E4419B-08A-S

S E R V I C E N O T E

Agilent E4419B EPM Power Meter

Correct Orientation of the Power Supply's Force-fit Connector

Figure 1: Interior Layout of Power Supply Unit, P/N: 0950-3681

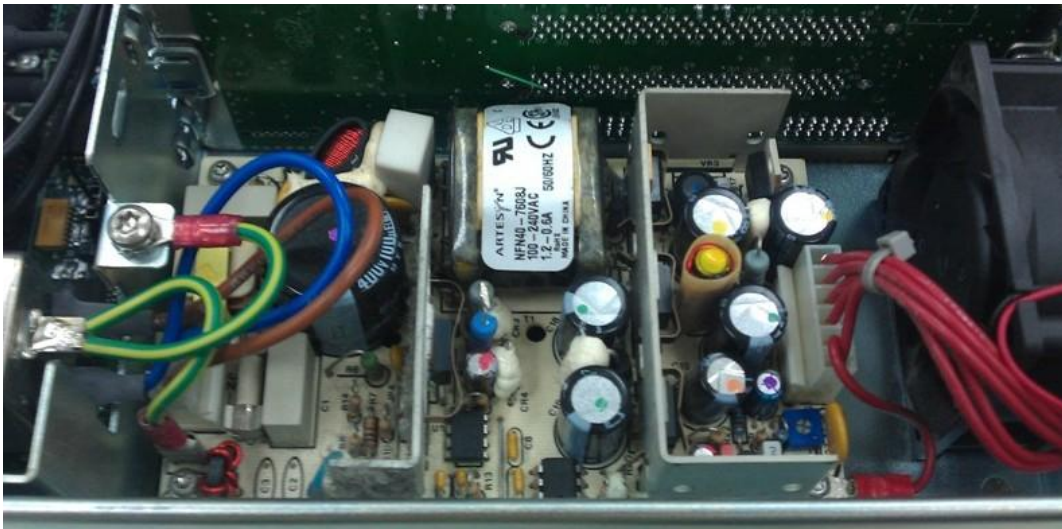
The Power Supply Unit, P/N: 0950-3681 has been replaced by another Power Supply Unit, P/N: 0950-2649 for the standard E4419B since June 2007 for E4419B with serial number MY45102599 onwards. The design layout of 0950-2649 is different from 0950-3681 and does not cause any possible shock hazard.

The interior layout of the respective power supply unit is shown in figure 1 and figure 2.

Figure 3: Correct orientation of force-fit connector.

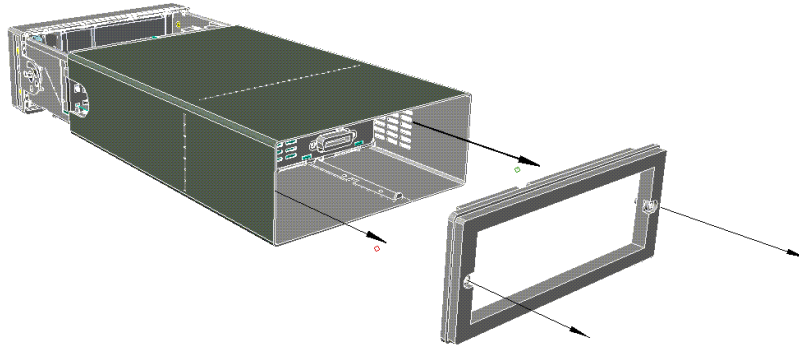
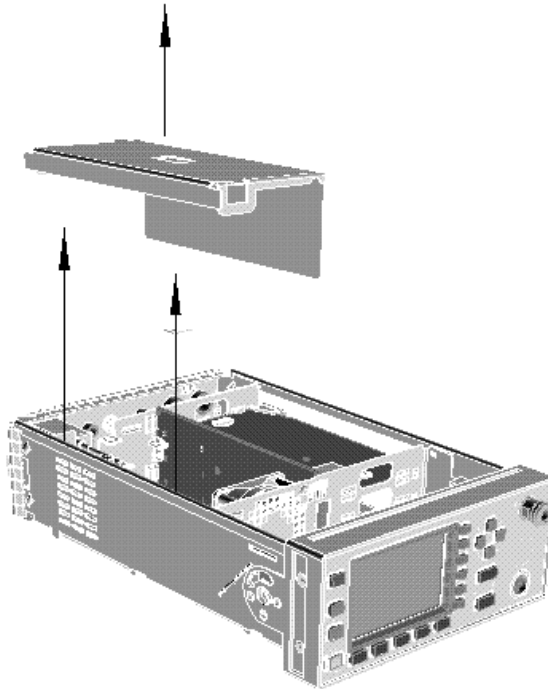
It has been highlighted that the force-fit connector connecting the earth wire to the Power Supply Unit, (P/N: 0950-3681) can be fitted in two different ways on the E4419B.

By fitting the connector with the bottom (flat) side facing the large capacitor on the Power Supply Unit, the gap between them is maximized (approximately 2mm).

By fitting the connector with the top (rounded) side facing the large capacitor on the Power Supply Unit, the gap between them is minimized (approximately 1.2mm).

The gap should be maximized at all times to ensure the unit meets the design and regulatory requirements relating to electrical insulation. This requirement is such that the gap should be at least 1.71mm.

Ensure that this connector is re-fitted such that the bottom (flat) side of it is facing the large capacitor on the Power Supply Unit, P/N: 0950-3681.
